# **Mobile Intel<sup>®</sup> Celeron<sup>™</sup> Processor at 466 MHz, 433 MHz, 400 MHz, 366 MHz, 333 MHz, 300 MHz, and 266 MHz Specification Update**

Release Date: August 2001

Order Number: 244444-026

**Figure 2. Workaround Flowchart: SMBALERT#-Driven System**

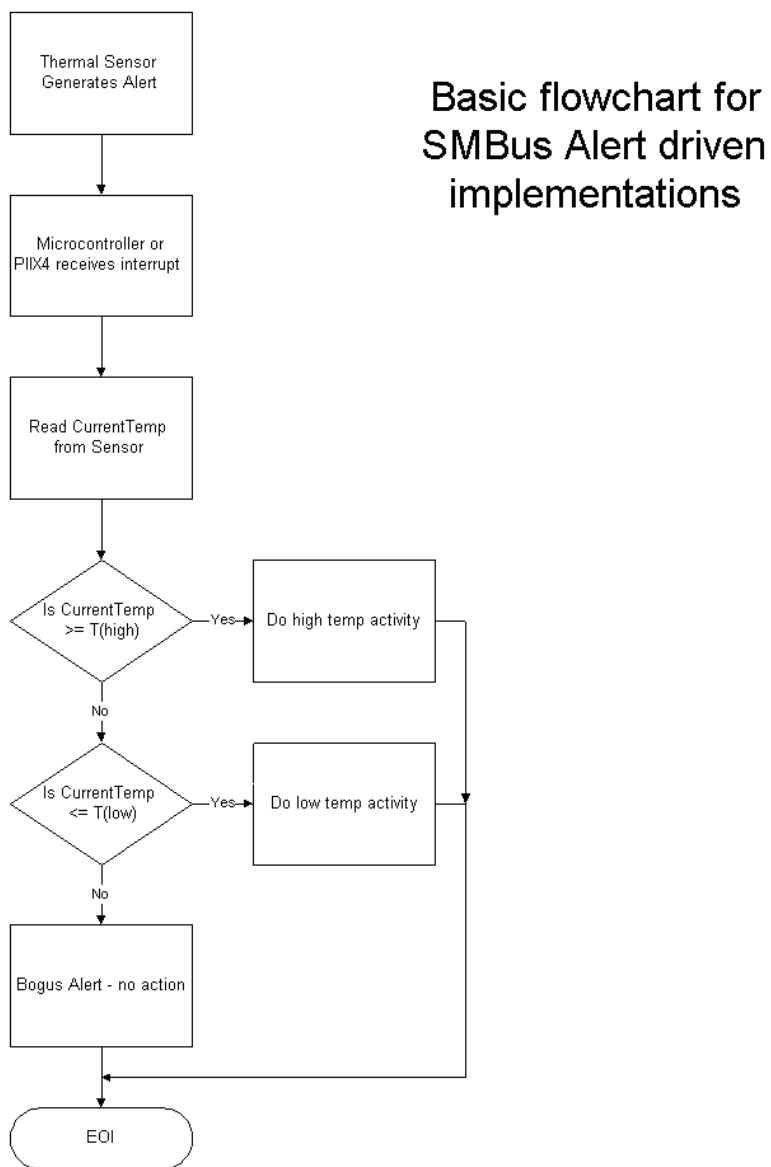
**Problem:** The Intel Celeron Processor Mobile Module has a thermal sensor that monitors the processor core's temperature. Please note that desktop systems could have a similar thermal device. The thermal sensor asserts SMBALERT# if the processor temperature exceeds the temperature limits set in the Alarm Threshold Registers (T<sub>HIGH</sub>, T<sub>LOW</sub>). It also sets the corresponding Status Register bits to identify the cause of the interrupt. Figure 1 gives one example of the how the SMBALERT# signal could be used in a system.

**Workaround:** Three different (mutually exclusive) workarounds are possible:

1. Before servicing an interrupt from the thermal sensor, read and compare the processor thermal reading with the threshold limits ( $T_{HIGH}$  or  $T_{LOW}$ ). Figures 2 and 3 provide basic flowcharts for the implementation of this workaround in an interrupt driven system.
2. If the firmware implemented polls the Status Register only, then before taking any action, re-read the temperature register and do a comparison with the alarm threshold limits ( $T_{HIGH}$  or  $T_{LOW}$ ) to determine if the value is actually still within the temperature window.
3. Use a temperature polling scheme to monitor the processor temperature.

Figure 5.3. Surface-Mount BGA1 Package—Top and Side View

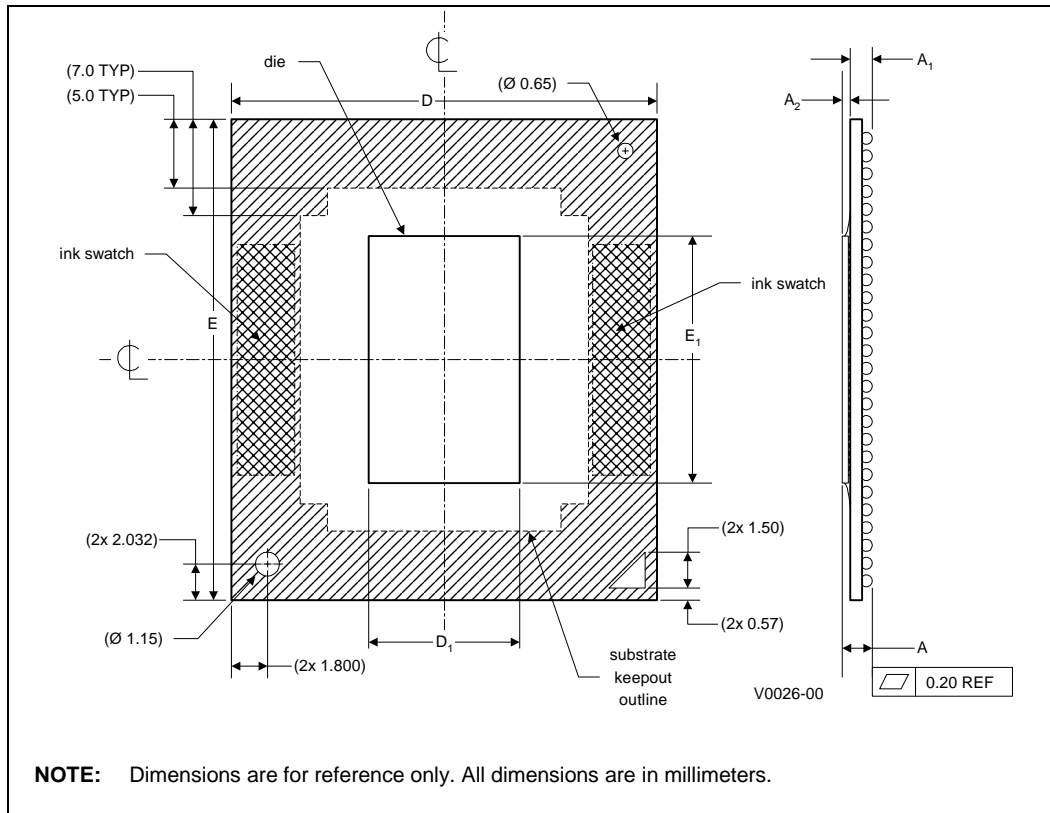
The following table and figures show the updated mechanical specifications for the BGA1 package, listed as Table 5.2, Figure 5.3 and 5.4, respectively, in the *Intel® Mobile Celeron™ Processor in BGA Package at 333 MHz, 300 MHz and 266 MHz* datasheet.

1. The number shown here is different from that in the 244444-004 version of this specification update. The maximum reference number is used.

Figure 3.3 Generic Clock Waveform

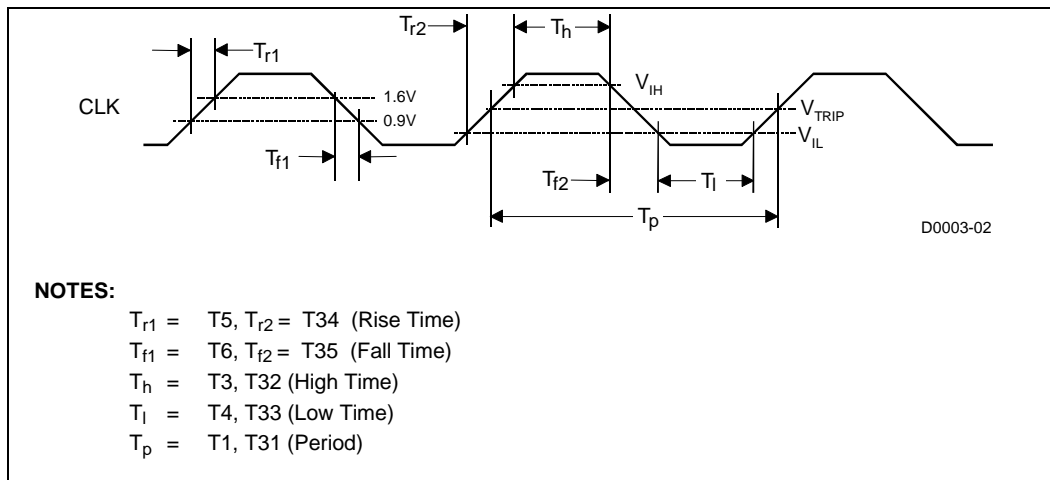
## H11. Generic Clock Waveform Figure

Figure 3.3 in the *Intel® Mobile Celeron™ Processor in  $\mu$ PGA1 and BGA1 Packages at 366 MHz, 333 MHz, 300 MHz, and 266 MHz* datasheet (Order Number 245112-003) has been updated. The following figure is to replace the one in the above document.
